Apalis iMX8 Starter Kit Errata Document

Errata #1: Module reboots due to too low overcurrent protection

Affected Version: **Starter Kit with Ixora (delivered before October 8 2018)**
Starter Kit with Apalis Evaluation Board (delivered before October 8 2018)

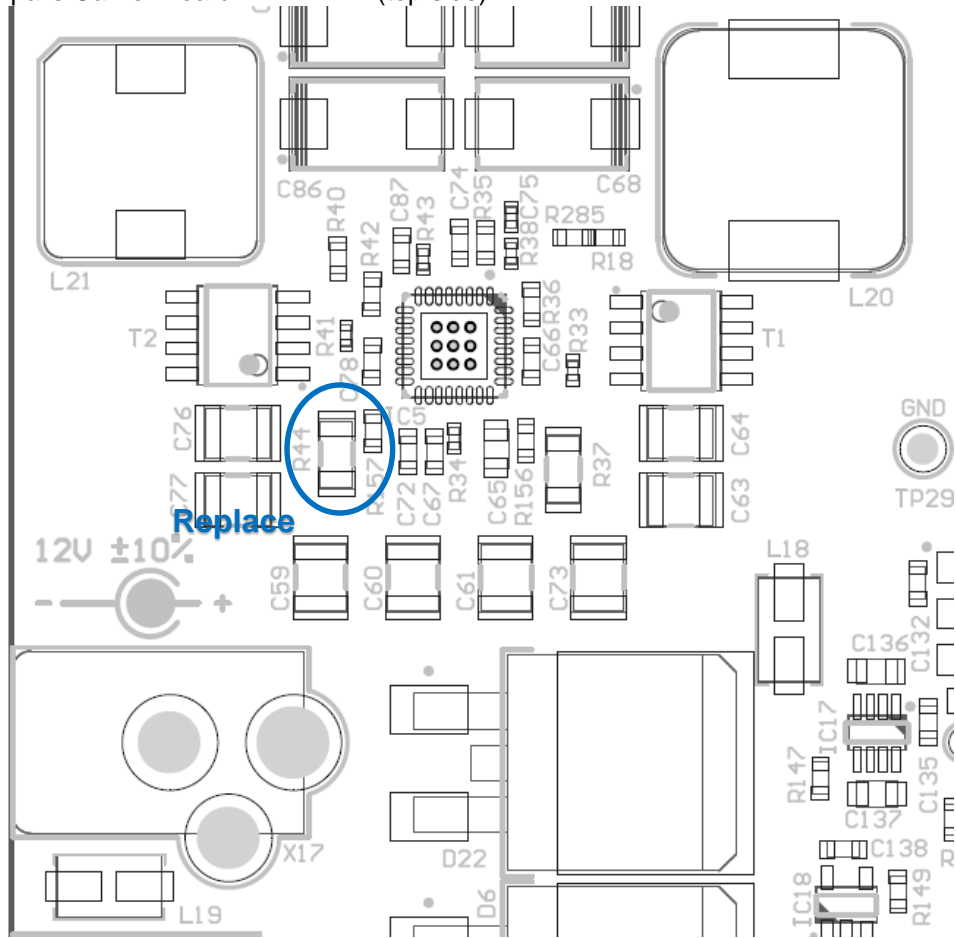
On all Carrier Boards in the Apalis iMX8 Starter Kits the current sensing resistors have been replaced by hand with a 0Ω resistor to allow for a higher current limit. Unfortunately, the tolerance of the new 0Ω resistor is too big so it is not exactly 0Ω, which can lead to a too low current limit of around 3A.

The 0Ω current sense resistor (R44) needs to be replaced with a resistor that has ≤ 10 mΩ resistance. This can be any 1206 sized **shunt** resistor with a resistor value of 10 mΩ or lower or a “true zero ohm” resistor with a low maximum resistance (for example Keystone 5108 https://www.keyelco.com/product.cfm/product_id/14040). Make sure the resistor is properly soldered. Use enough heat and solder.

Alternatively, it is possible to short the current sense resistor. Use thick piece of wire or desoldering braid. The total resistance of the connection needs to be below 10 mΩ

- Apalis Carrier Board V1.1A **R44** (top side)

- Ixora V1.0A **R9** (top side)
